SUBJECT: Interagency Agreement No. NRC-03-79-167, Bi-monthly Letter

SUBJECT: REQUEST FOR ADDITIONAL FIELD EXPLORATIONS AND INFORMATION

PLANT NAME: Midland Plants, Units 1 and 2
LICENSING STAGE: Post CP
DOCKET NUMBERS: 50-329/330
RESPONSIBLE BRANCH: LB No. 3; D. Hood, PM
REQUESTED COMPLETION DATE: N/A
REVIEW STATUS: Continuing

MIDLAND PLANT - UNITS 1 AND 2
CONSUMERS POWER COMPANY
DOCKET NO. 50-329/330
QUESTIONS AND POSITIONS-GEOTECHNICAL ENGINEERING
PREPARED BY: J. D. Kane, GES, HGB
from the review comments of
the U. S. Army Corps of Engineers,
Detroit District

Tabel Q 362.19-1

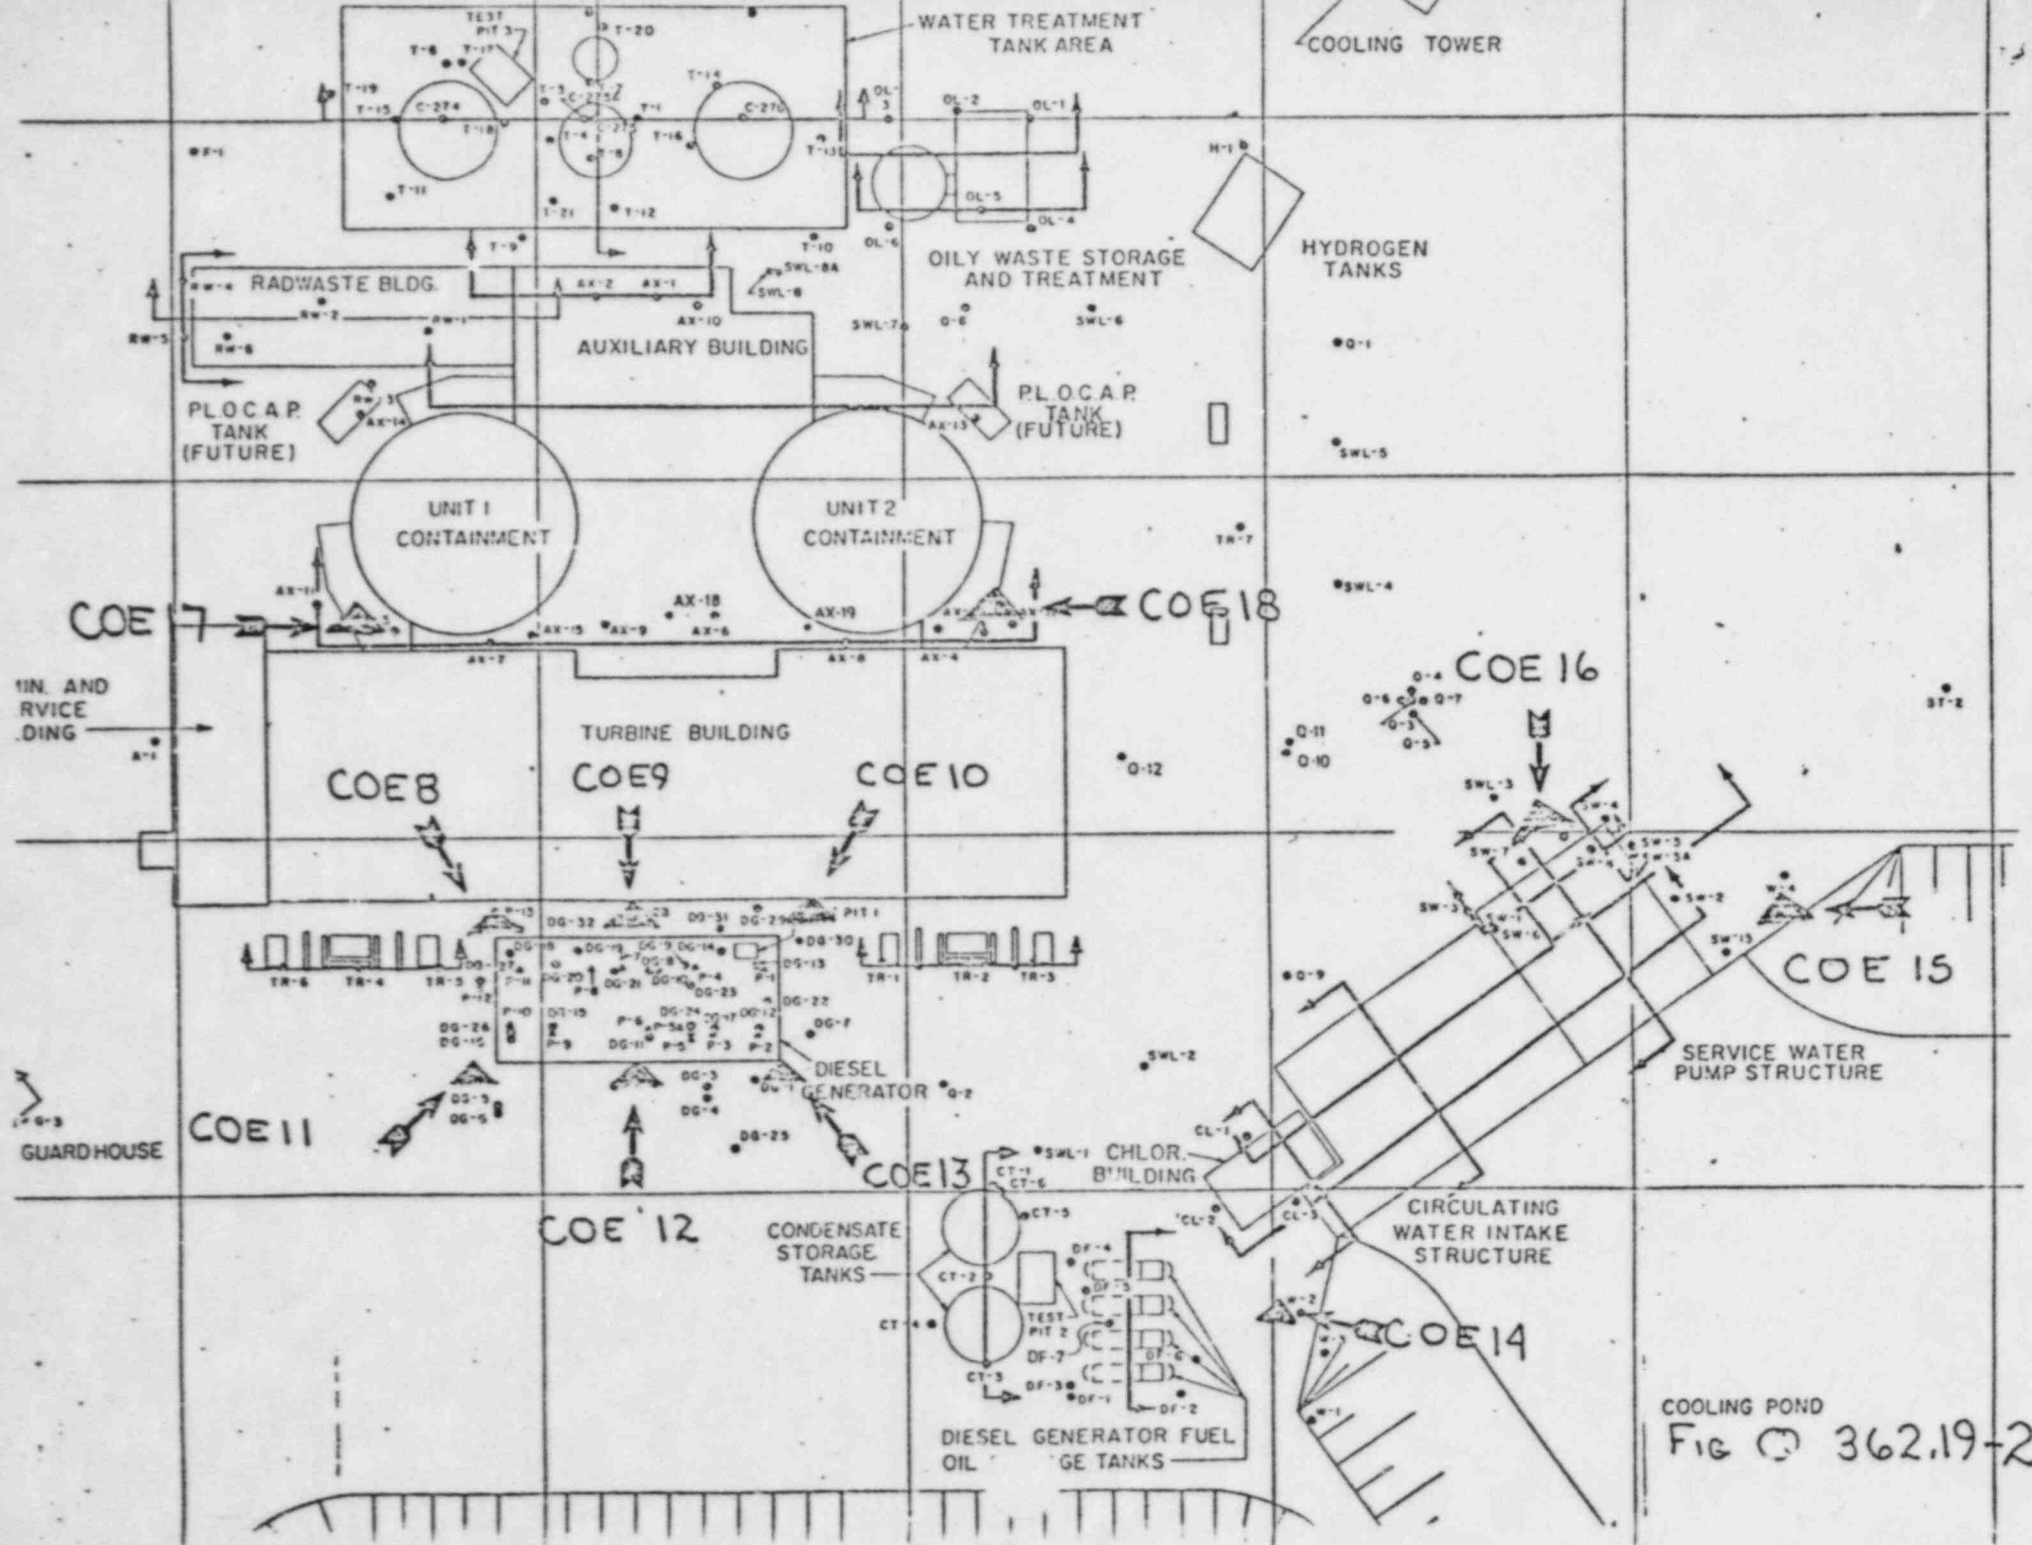
- 362.19
(RSP)
(Quest. 5 & 35)
- The refusal of the Applicant in previous responses to Questions 5 and 35 to complete additional explorations, sampling and laboratory testing following the preload program is unacceptable to the staff. We require that CPCo complete as a minimum, the exploration and testing program indicated on Table Q 362.19-1. Several reasons for not accepting the Applicant's previous responses include:

- 1/ See attached Fig. Q 362.19-1 for approximate boring location. Holes to be accurately located in the field to avoid obstructions, underground piping and conduits and slurry trench area.

- 2/ No boring is to be terminated in loose or soft soils.
- 3/ Continuous split spoon sampling using SPT is required. Holes are to be held open ~~with casing~~ using either casing or hollow stem auger. Additional borings to obtain representative undisturbed samples for detailed laboratory testing should be located at the completion and evaluation of the split spoon sampling program. The groundwater level should be recorded at the completion of drilling in all borings once the level has stabilized.

- 4/ Normal classification (e.g., gradation, Atterberg Limits) unit weight and moisture content testing to be performed on representative samples from each significant foundation layer. This column pertains to lab testing in addition to the above mentioned tests. It is requested that at least one week notice be provided to the NRC before opening undisturbed samples to permit on site visual observation by Corps of Engineer representative.

- 5/ The maximum load should be great enough to establish the straight-line portion of the void ratio-pressure curve.

Fig 362.19-1

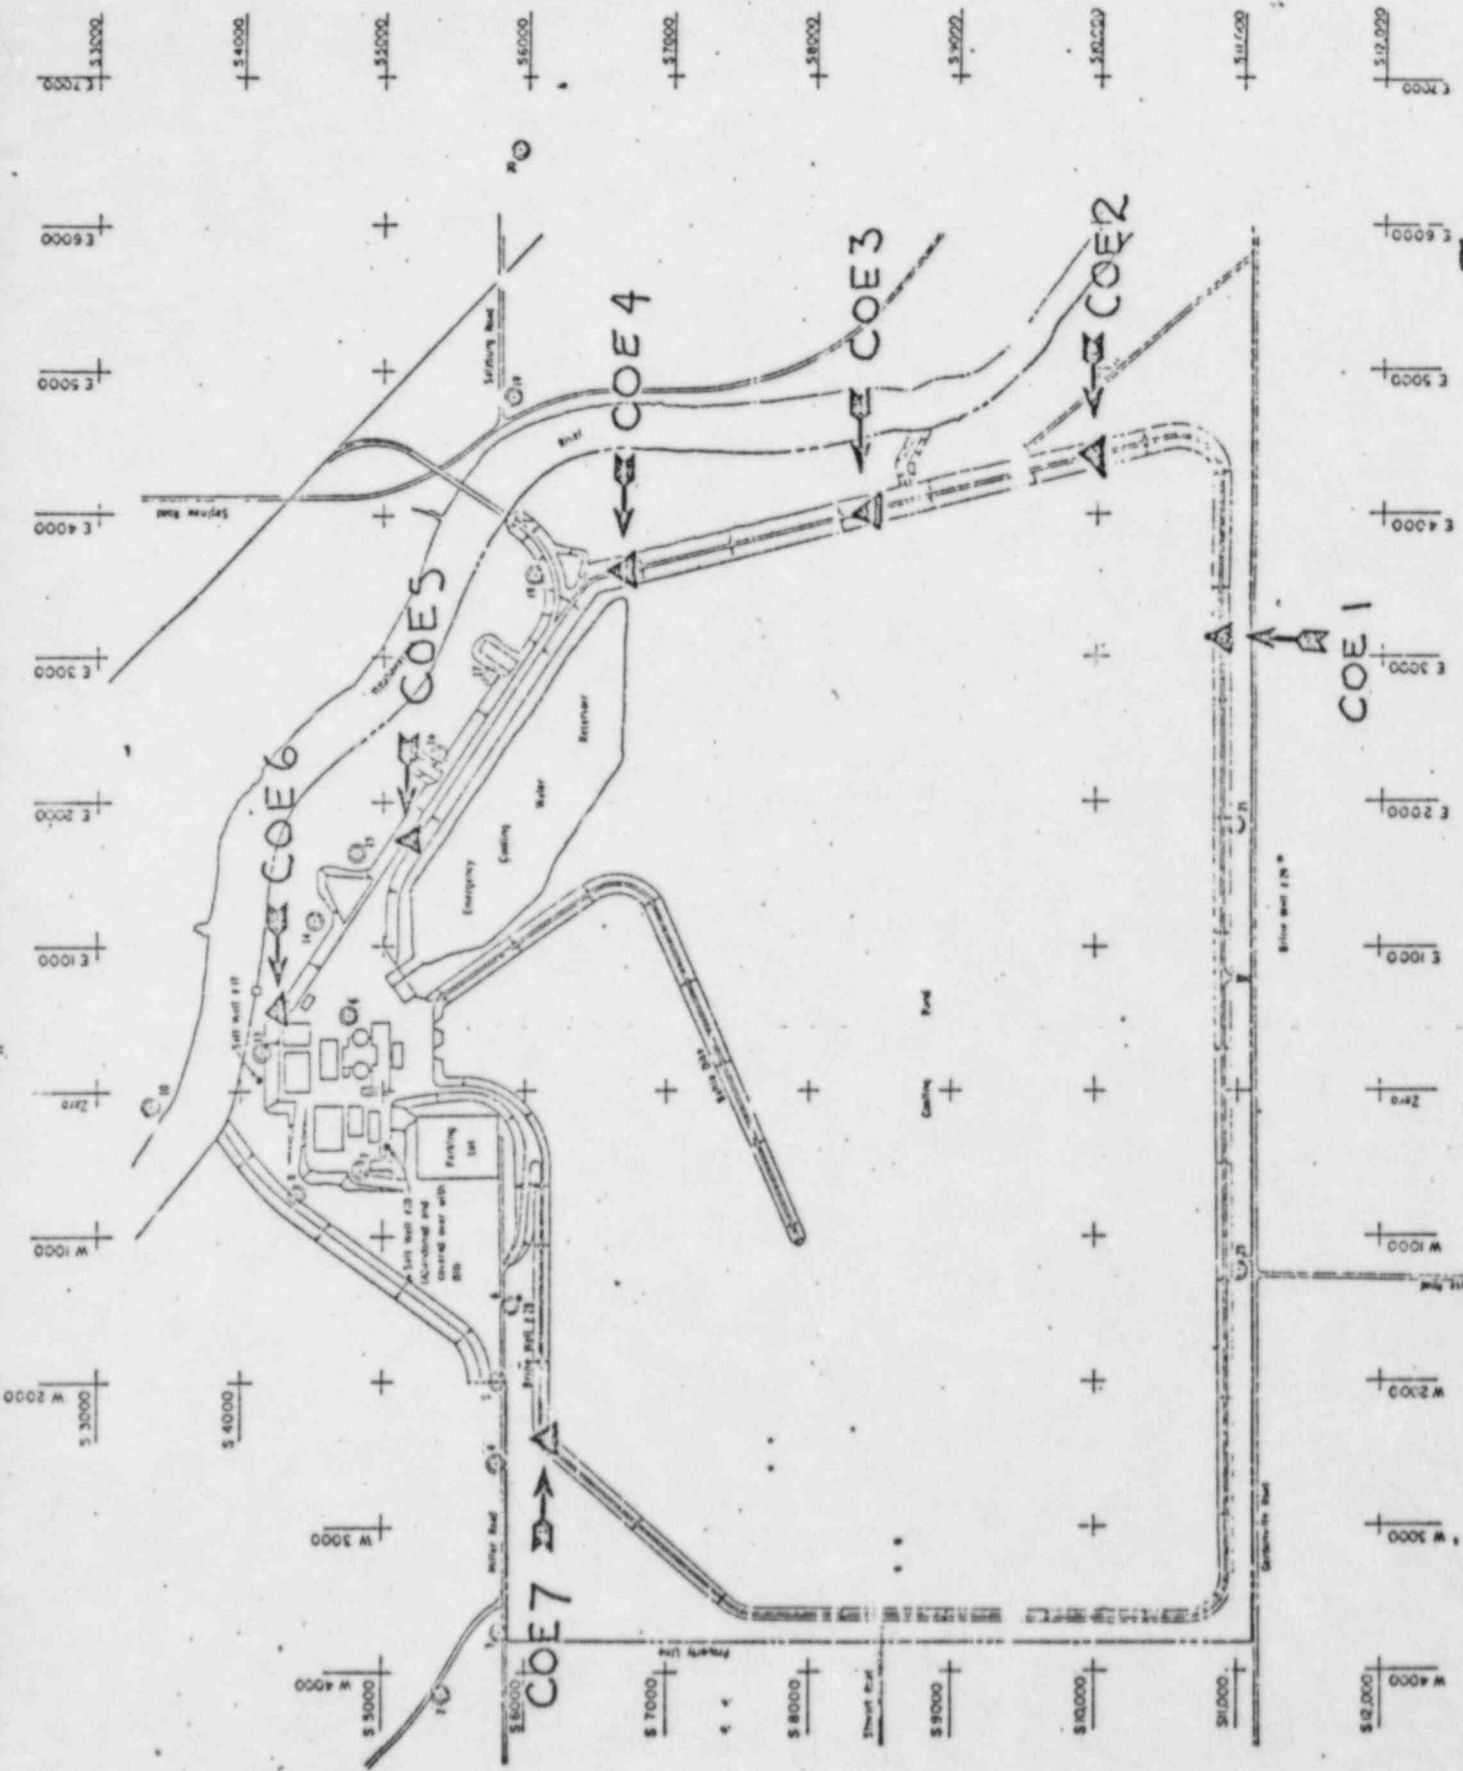
7. A need exists for additional borings, since random exploratory borings throughout the plant site have revealed pockets of soft clay subject to settlement and or consolidation and loose sands subject to liquefaction. A need also exists to check the results of the proposed remedial measures of surcharge loading at the Diesel Generator Building and the dewatering plan.

a. In the case of the Diesel Generator Building, check borings must be made in the vicinity of borings which identified low "u" values in the clay and sand fill. The proposed borings shall be carried into the glacial till and all samples, including those in the glacial till, treated as indicated below.

The borings locations are as indicated on the attached map. All soil for the full depths of the borings shall be classified according to the Unified Soil Classification System. Any tests necessary to classify the soil shall be accomplished. Unit weight and moisture content of all samples should also be determined. The samples obtained from any cohesive strata shall be tested. The tests for cohesive material shall be a consolidation drained and undrained triaxial shear tests (UBS) and a consolidation test, with restraining load equal to the load in-place at the strata depth. The sample represents. The sands shall be tested in direct shear for a loose and dense condition and the relative density of the sand in situ determined.

a. Diesel Generator building - 4-6 holes around the perimeter of the building. Samples of all strata from ground surface into the glacial till (holes 8-13). Include (downhole, crosshole and surface geophysical tests to establish in situ compression and shear moduli for floor response spectra design check mentioned on pg. 18 & VII-4 of Interim S&C dated 11/11/73
 What about consolidation tests to establish secondary compression characteristics?
 (Ref., pg 114, Tong & Winterhara)

b. Auxiliary Building - Take two borings around the proposed support piling or caisson for remedial protection of loose sands and soft clays adjacent to pile or caisson to stiffen piles and adjoining ground against lateral loading. Borings need to penetrate to glacial till. (see attached map for boring locations - holes 4 & 5.)

c. Service Water Building - A boring (hole 16) shall be made as indicated on the attached map to ~~and~~ into the glacial till. All samples obtained shall be classified according to the Unified Soil Classification System also Consolidation, drained and undrained triaxial compression tests made on cohesive soil samples, and direct shears for a loose and dense condition shall be made on all granular soil samples, as specified in paragraph 7E.

d. Plant Area Borings - If feasible, some borings should be taken under the Radwaste and Turbine Buildings to determine if unwatered pockets exist or persist. Suggested boring locations would be as indicated on the attached map. Further investigation could be needed after the results of these borings are obtained. No borings presently exist in these areas. The borings should be case or hollow stem auger borings with drive samples every 2-1/2 feet through the fill. The holes should be converted to dewatering holes or used for piezometers (Holes 1, 2, 3, 6 & 7). *Don't specify this.*
